Planning Updates - NMA 1
ECMWF-BDP-ZZ-ZZ-RP-Z-000500
Revision - P02
05.07.24

Elevations comparison

West Elevation

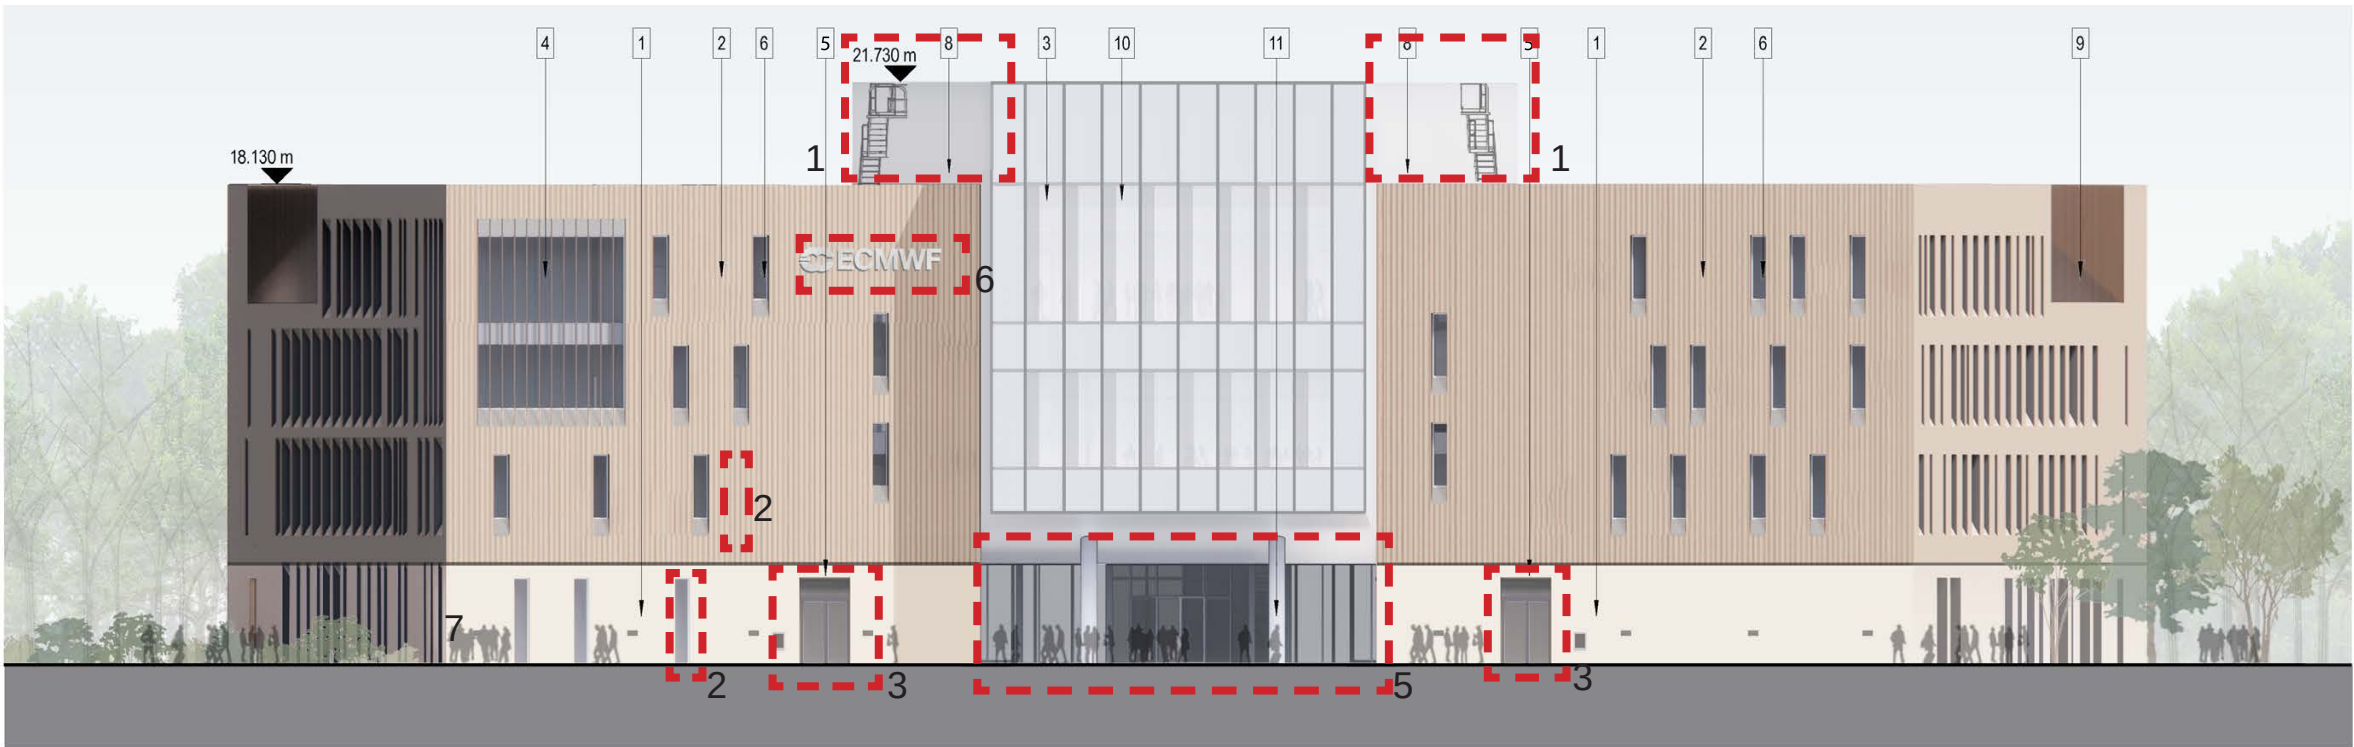
- 1. Ladder added to access beacon roof PVs
- 2. Window & doors relocated in response to internal replanning.
- 3. Door changed from glass to solid metal door.
- 4. Louver resized in response to internal replanning.
- 5. Main entrance curtain wall has been pulled out in line of draft lobby.
- 6. Logo updated
- 7. Dry riser and facade lighting added on ground floor facade

East Elevation

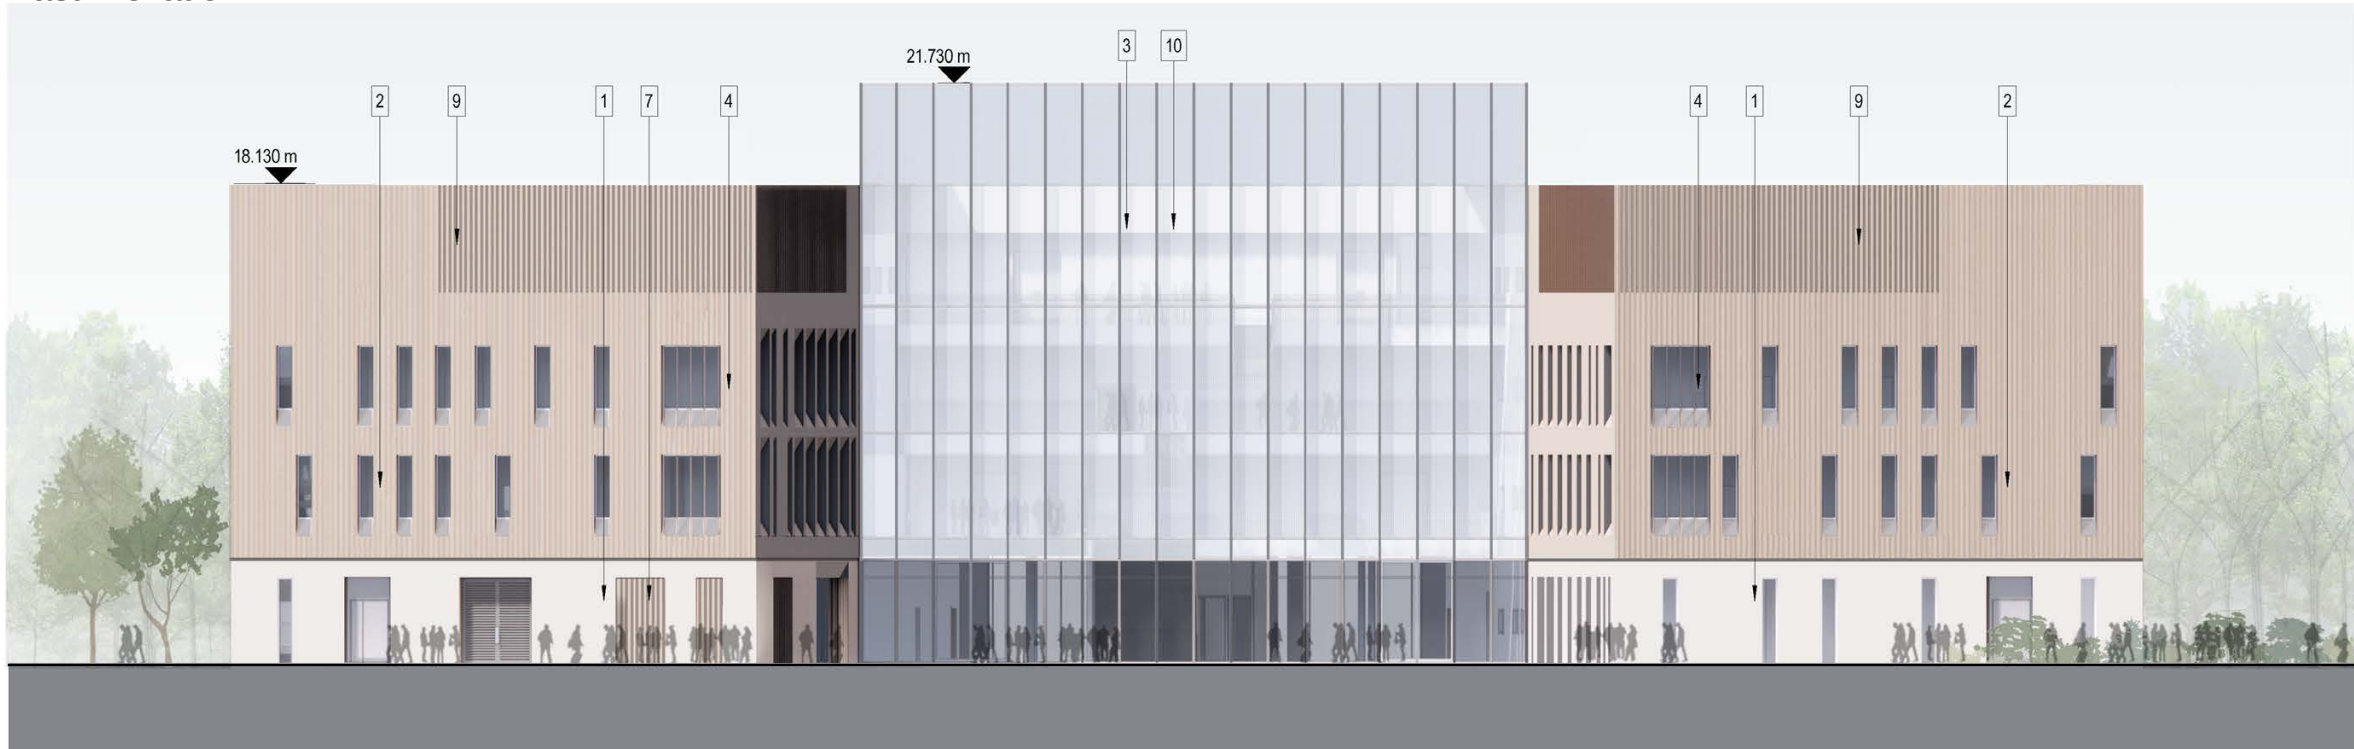
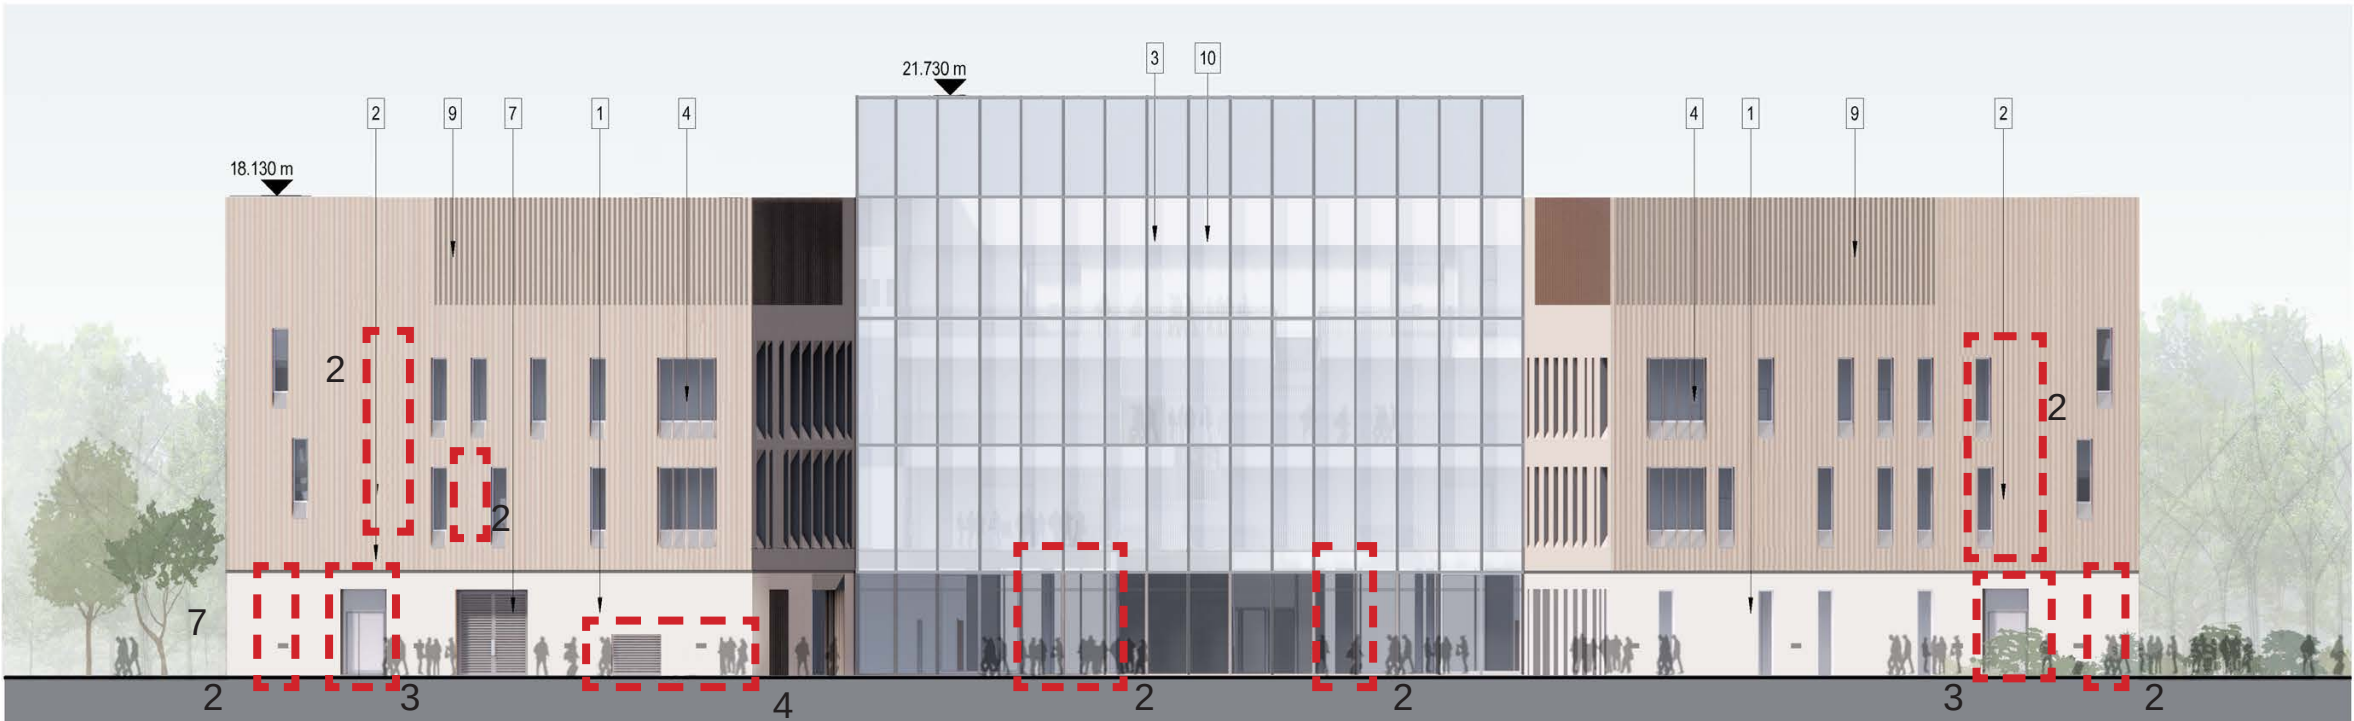
- 1. Ladder added to access beacon roof PVs
- 2. Window & doors relocated in response to internal replanning.
- 3. Door changed from glass to solid metal door.
- 4. Louver resized in response to internal replanning.
- 5. Main entrance curtain wall has been pulled out in line of draft lobby.
- 6. Logo updated
- 7. Dry riser and facade lighting added on ground floor facade

North Elevation

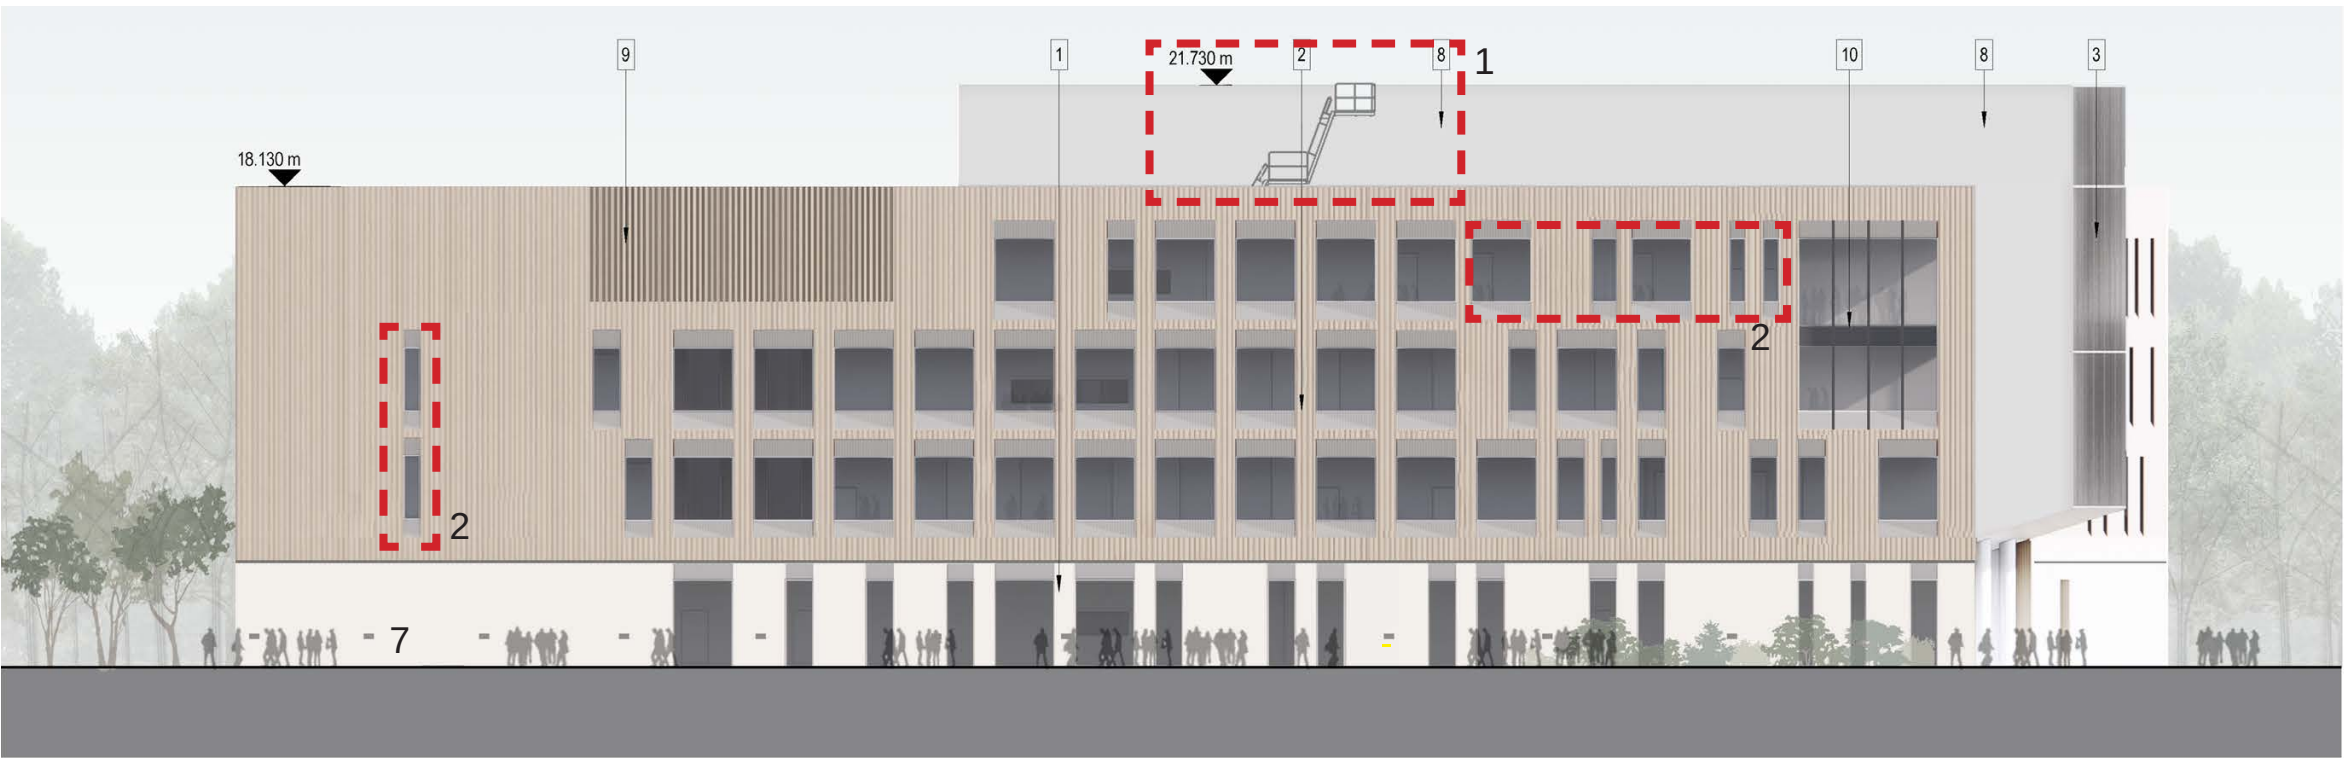
- 1. Ladder added to access beacon roof PVs
- 2. Window & doors relocated in response to internal replanning.
- 3. Door changed from glass to solid metal door.
- 4. Louver resized in response to internal replanning.
- 5. Main entrance curtain wall has been pulled out in line of draft lobby.
- 6. Logo updated
- 7. Dry riser and facade lighting added on ground floor facade

South Elevation

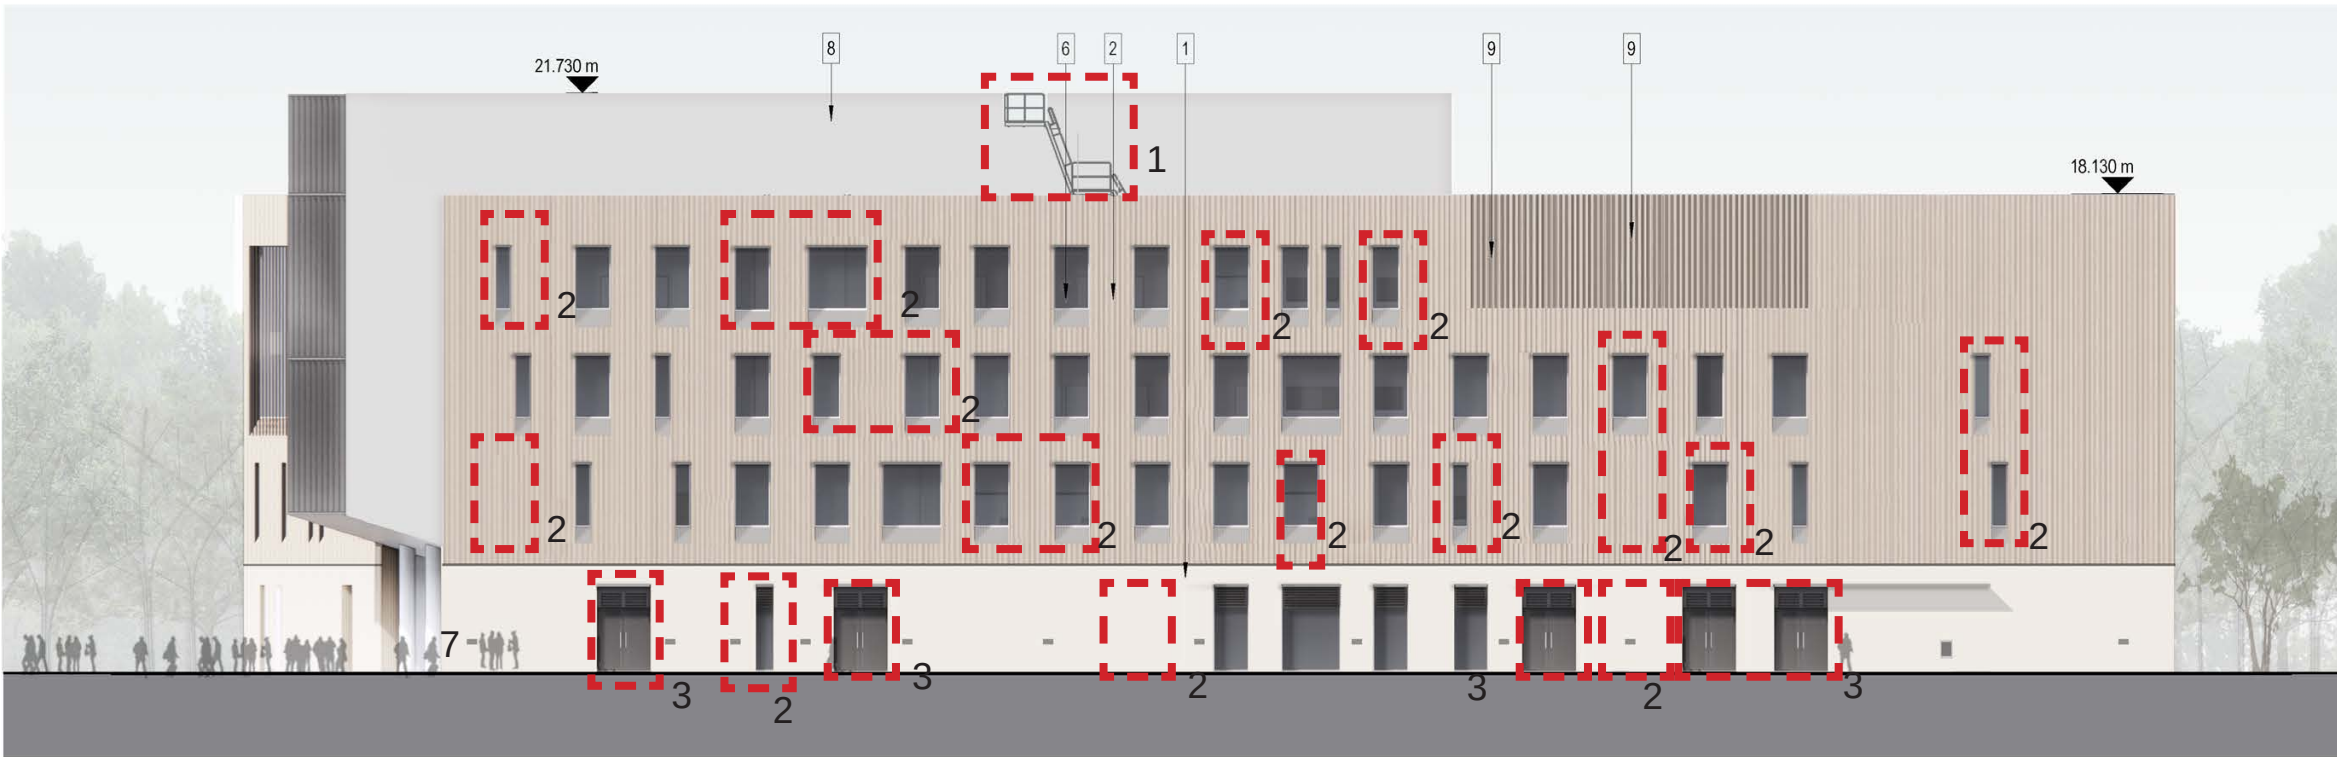
- 1. Ladder added to access beacon roof PVs
- 2. Window & doors relocated in response to internal replanning.
- 3. Door changed from glass to solid metal door.
- 4. Louver resized in response to internal replanning.
- 5. Main entrance curtain wall has been pulled out in line of draft lobby.
- 6. Logo updated
- 7. Dry riser and facade lighting added on ground floor facade
